**DEPARTMENT OF PLANNING AND ZONING
PLANNER'S REPORT**

DATE: June 29, 2019
TO: Tonya Hutson
FROM: Michael Smith
VIA: Lynn Patterson
RE: **Design Review – 3093 Hope Street Remodel**

FRONT ELEVATION "PROPOSED"
 SCALE: 3/16" = 1'-0"

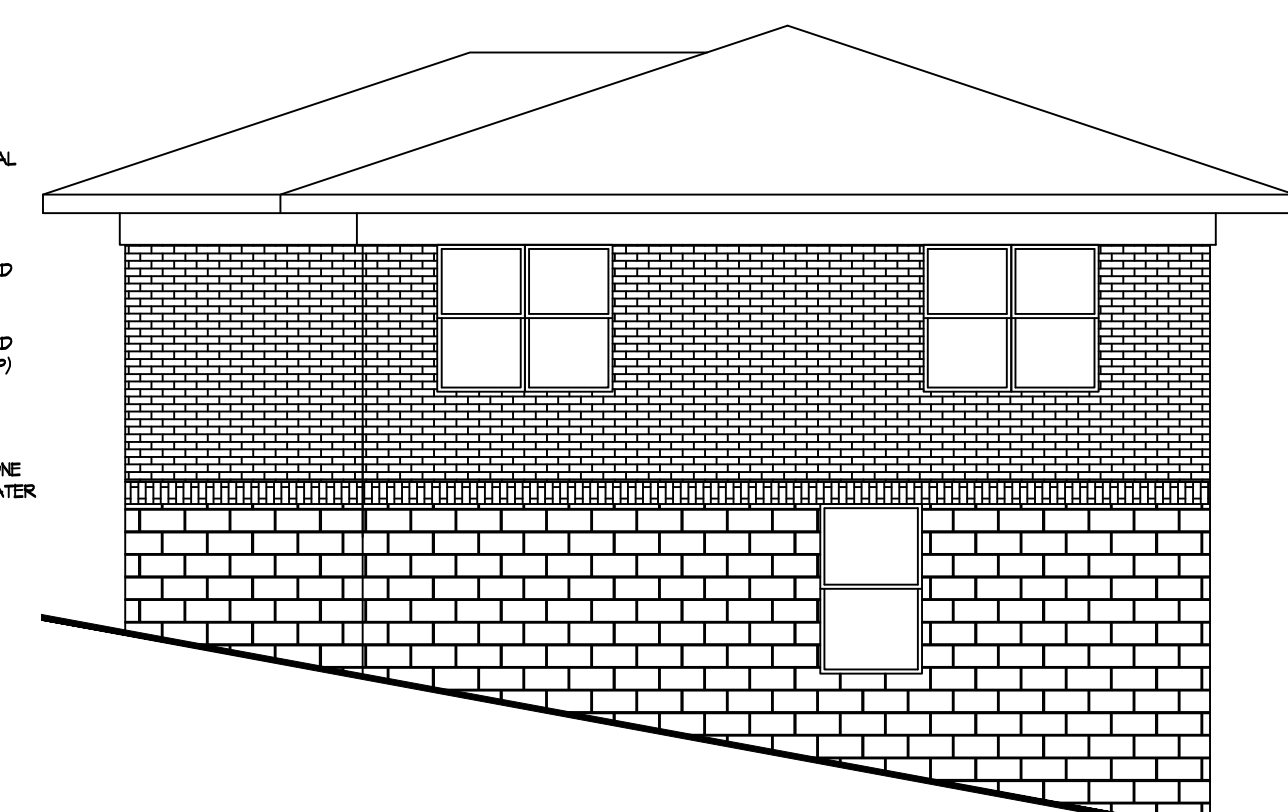
- **The Applicant is proposing a new stacked stone veneer for the foundation along the front façade. No other façade changes are within the scope of the project.**
